Information Request Response

Client: Amoeba Infinity Pty Ltd
Project: 60 Jamieson Street, Bulimba
Project No: 1916
Date: January 2020
Project Contact: Rhys Trombetta

Following the lodgement of an application for a Dual Occupancy and associated 1:2 Lot Subdivision, an Information Request was issued, dated 21 November 2019.

Coastal hazard overlay

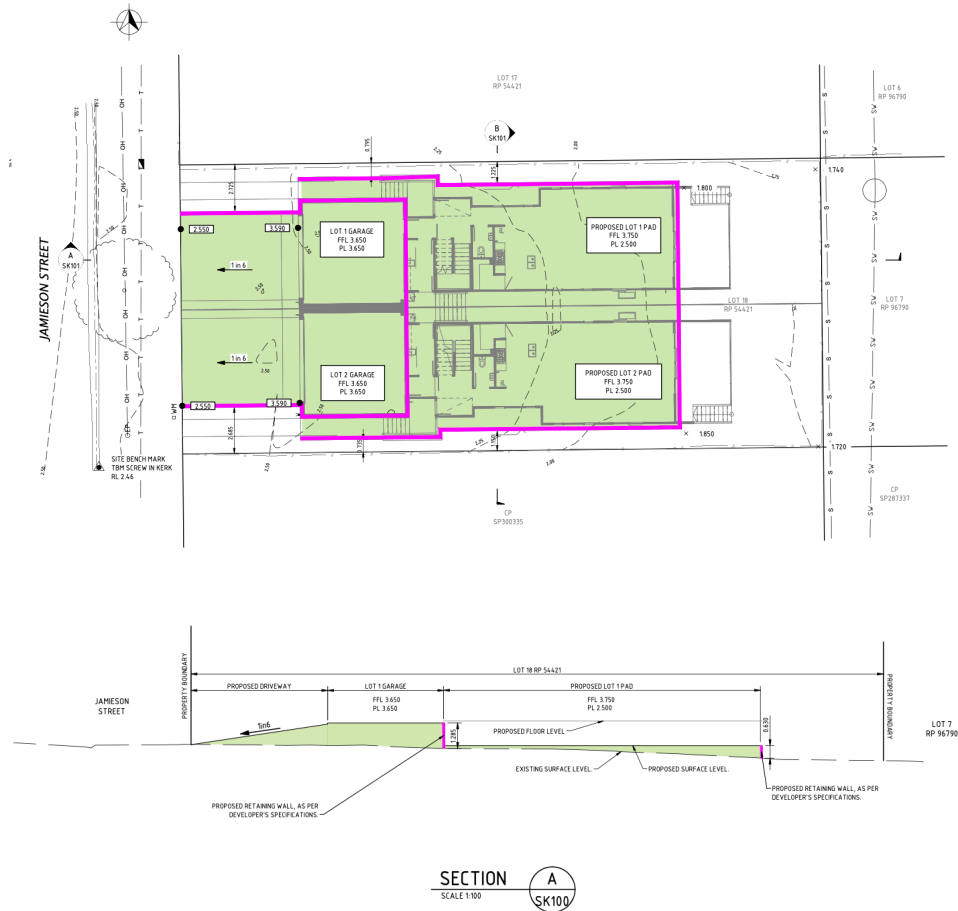
- 1) The proposed flood report does not sufficiently address the flood immunity requirements for the building floor levels in accordance with the Flood overlay code and the Coastal hazard overlay code. The creation of new lots requires at least 80% of the lot to be at or above the required level of 2.5m AHD. The extent of filling proposed would need to be addressed in a revised flood report to ensure filling does not create adverse impacts to surrounding properties or alternatively remove the reconfiguration of lots component of the application to negate the requirements for lot flood immunity.

- a. Please provide amended plans to ensure 80% of the lot to be at or above the above required level of 2.5m AHD in accordance with AO12 of the Coastal hazard overlay code; and

- b. Provide a revised flood report to ensure filling proposed complies with the relevant Planning Scheme requirements in accordance with AO12 of the Coastal hazard overlay code.

Attached is an Engineering Plan which depicts the location and height of proposed fill on the site. 70% Flood Immunity has been achieved with further information provided within the Engineering Report addressing the criteria of the performance outcome.

During a meeting with Council, it was advised that lower level decking space may be considered as part of the justification in addressing the criteria of the Coastal Hazard Overlay Code – this decking space has not been provided on the plans as the degree of flood immune land that has been able to be achieved far exceeds what was initially expected, and the 10% difference in decking space would not provide a useable area, resulting in the lessening of private open space available to the dwelling occupants outside of flood events.

The amended Engineering Documentation has received preliminary feedback from the assessing engineer and has been determined to be supported in principle, subject to review following the lodgement of this formal response to IR.
